FED. ROAD REG. NO.	STATE	FEDERAL AID PROJECT NO.	SHEET NO.	TOTAL SHEETS
1	NY		10	15
DELAWARE PT 2, S.H.41				
ALBANY COUNTY

± STA. 112+01.7 TO ± STA. 117+39.8

PLAN

STATE OF NEW YORK
DEPARTMENT OF TRANSPORTATION

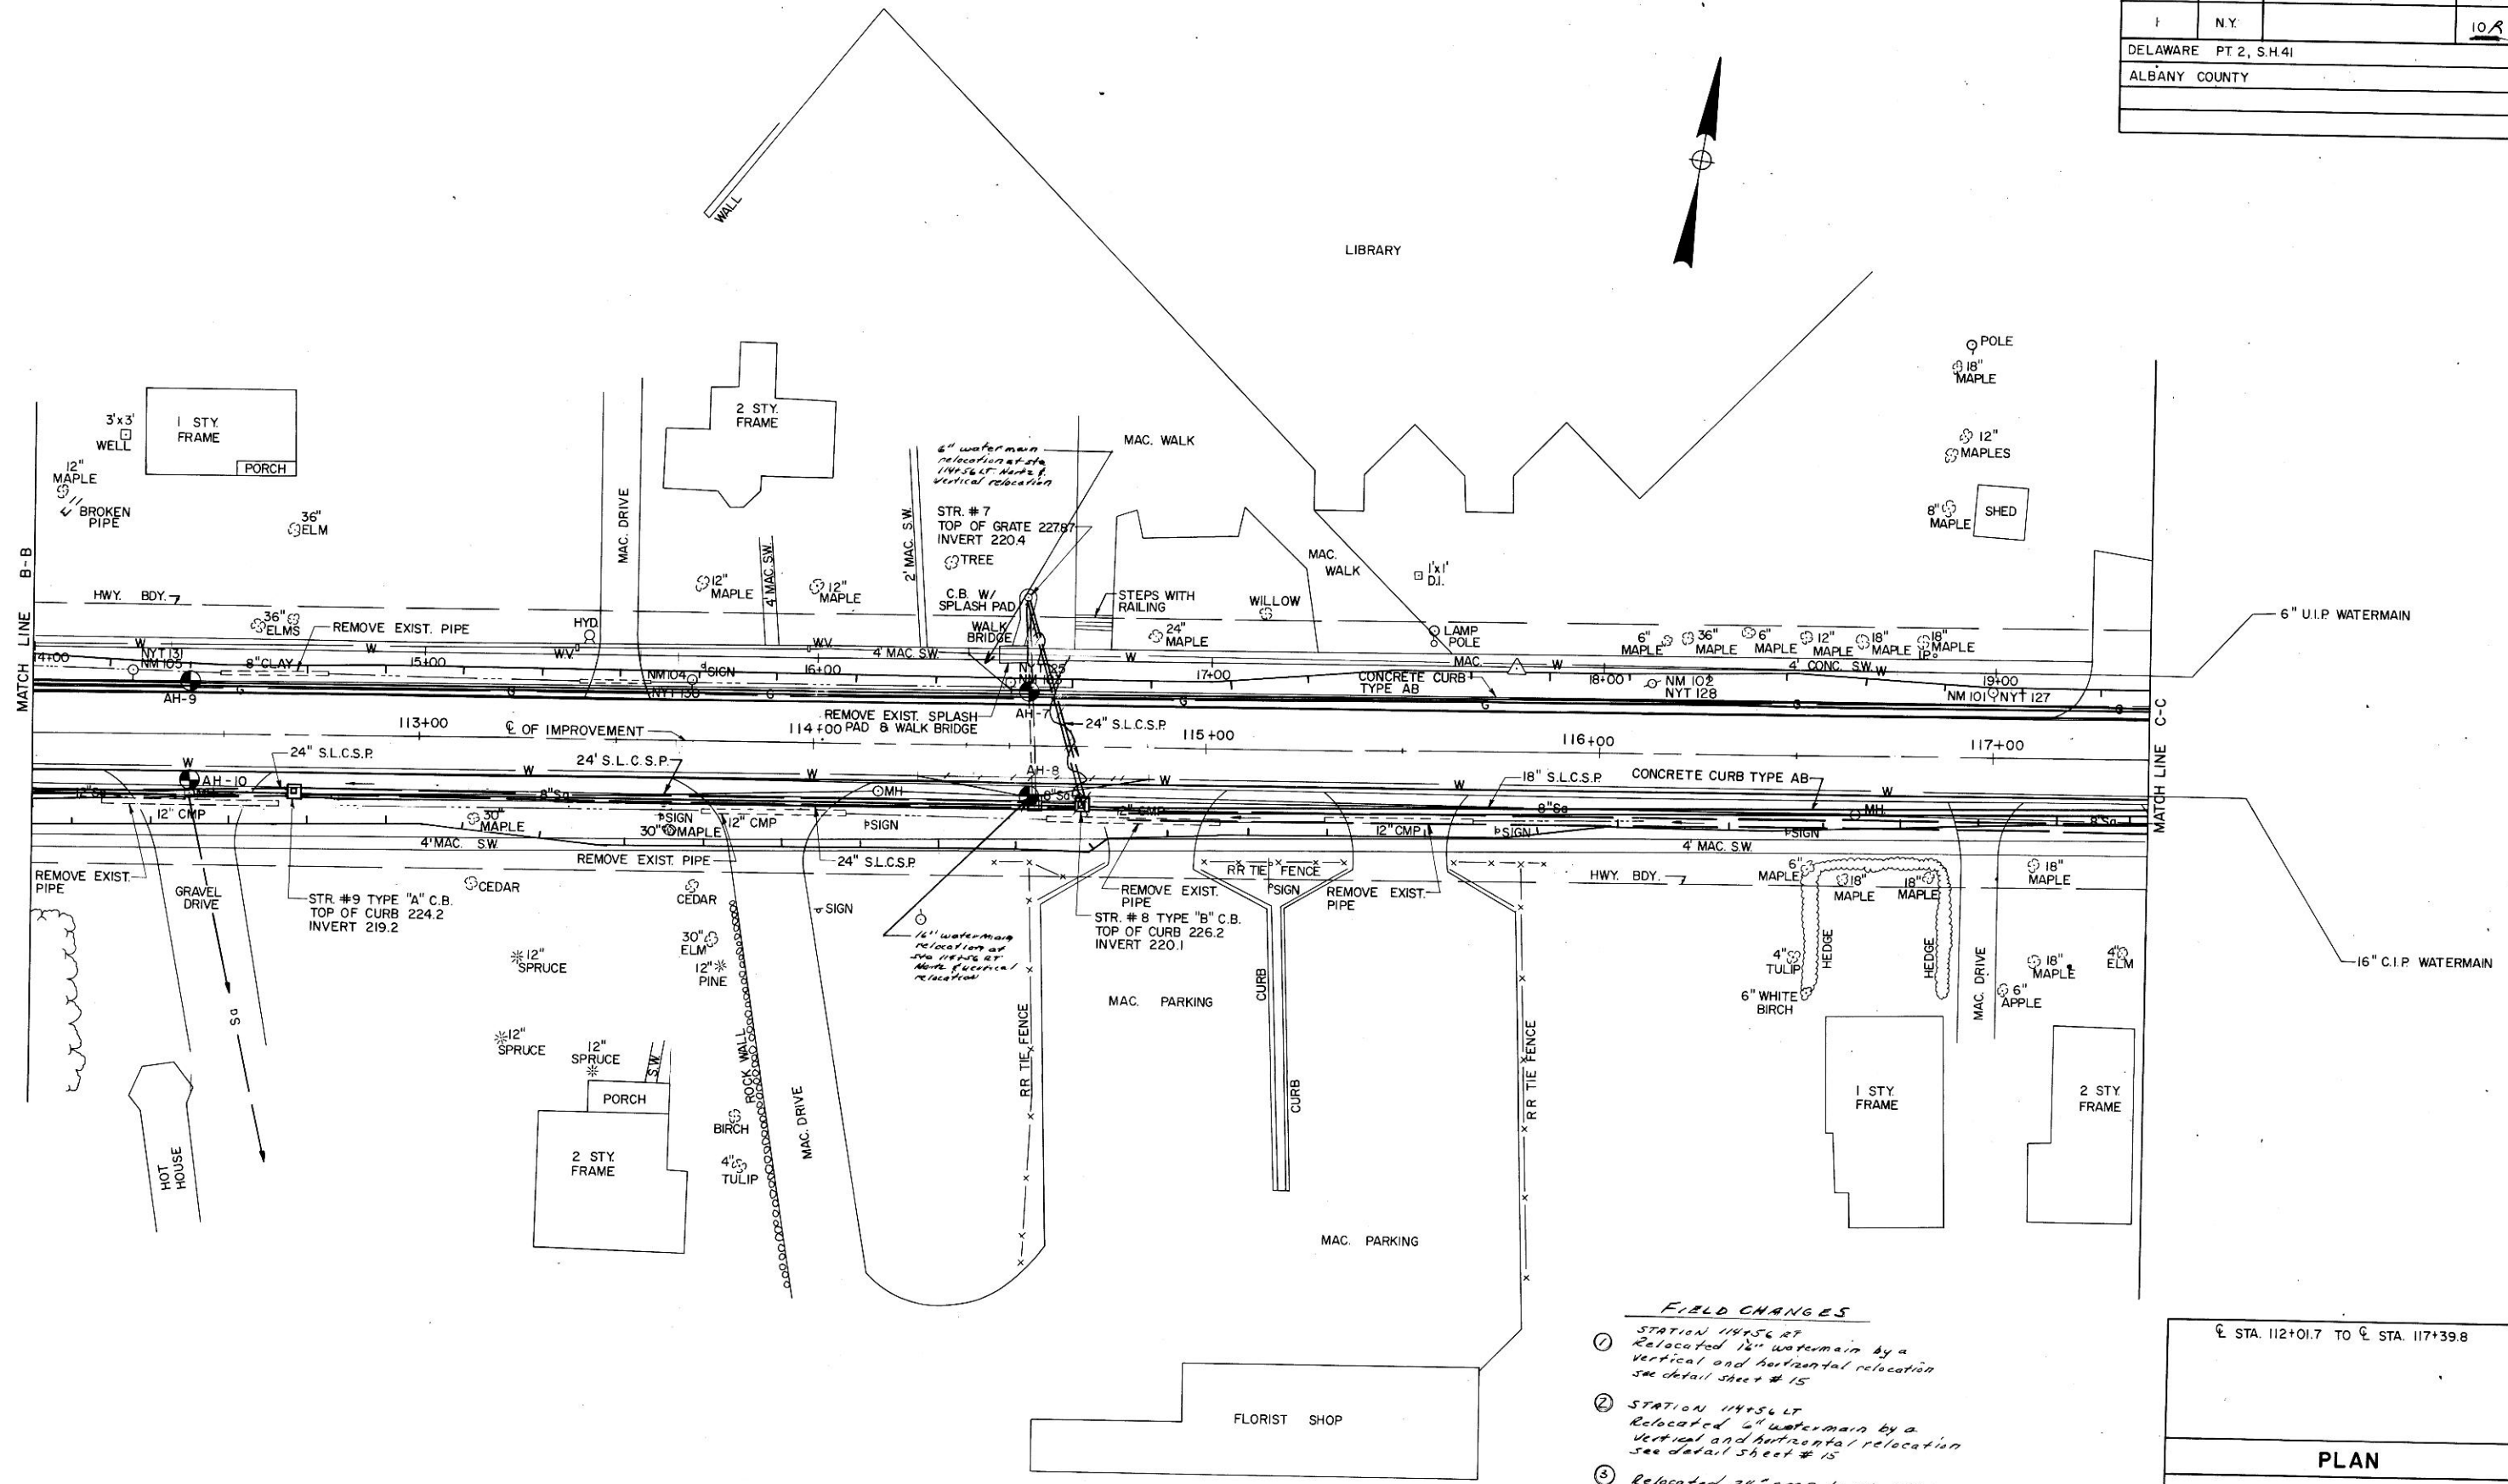
- FIELD CHANGES**
- ① STATION 114+56.7
Relocated 12" watermain by a vertical and horizontal relocation see detail sheet # 15
 - ② STATION 114+56.7
Relocated 12" watermain by a vertical and horizontal relocation see detail sheet # 15
 - ③ Relocated 24" CMP to sta 114+56 30' 20" skew RT AH
